Access Compliance Report

Public Rights-of-Way

(Curb Ramps)

Intersection ID: 27422	Main Street: BALLANTYNE_COMMONS_PY	Cross Street: STONEBRIAR_DR	Location: NW
ADA ID: 910461342C96	Ramp Type: Perp	Initial Pass/Fail: Fail	Overall Compliance: No
Severity Score: 33.75			
Codes/Mitigation Info/Possible Solution		Field Measurements/Component Compliance

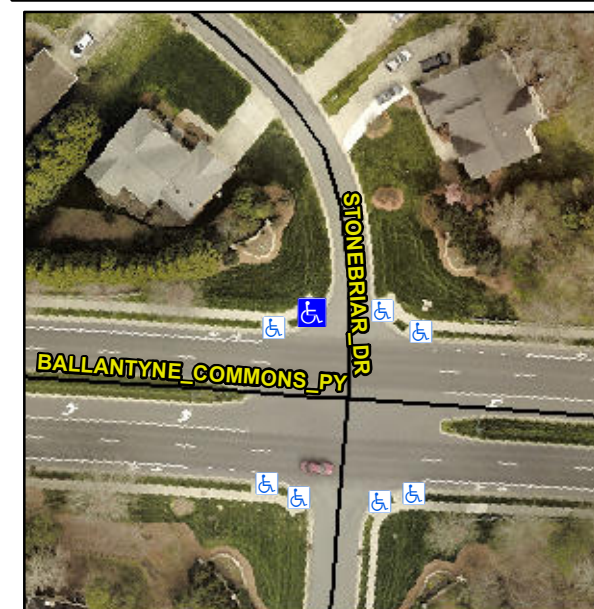
Not Found, R304.5.1, R304.2.2, R304.5.3

Compliance	Description	Data	Compliance	Description	Data
N/A	Ramp Length (in)	55.5	No	Ramp Slope (%)	8.5
No	Ramp Width (in)	37.0	No	Ramp XSlope (%)	6.0
N/A	Flare Type LT	N/A	N/A	Flare Type RT	N/A
N/A	Flare Slope LT (%)	N/A	N/A	Flare Slope RT (%)	N/A
N/A	Flare Traversable LT?	N/A	N/A	Flare Traversable RT?	N/A
N/A	Landing Length (in)	N/A	N/A	DWS Provided?	N/A
N/A	Landing Width (in)	N/A	N/A	DWS Contrast?	N/A
N/A	Landing Slope (%)	N/A	N/A	DWS Length (in)	N/A
N/A	Landing X Slope (%)	N/A	N/A	DWS Full Width?	N/A
N/A	Landing Curb? (Y/N)	N/A	N/A	DWS Offset (in)	N/A
N/A	Shared Landing?	N/A			
N/A	Gutter Ponding?	N/A	N/A	Gutter Slope (%)	N/A
N/A	Gutter Lip Ht (in)	N/A	N/A	Gutter X Slope (%)	N/A
N/A	Painted X Walk1?	No	N/A	Painted X Walk2?	N/A
	X Walk 1 Direction	To E		X Walk 2 Direction	N/A
N/A	X Walk 1 Width (in)	N/A	N/A	X Walk 2 Width (in)	N/A
	X Walk 1 Slope (%)	2.9		X Walk 2 Slope (%)	N/A
	X Walk 1 X Slope (%)	4.8		X Walk 2 X Slope (%)	N/A

Remove & Replace Entire Ramp.
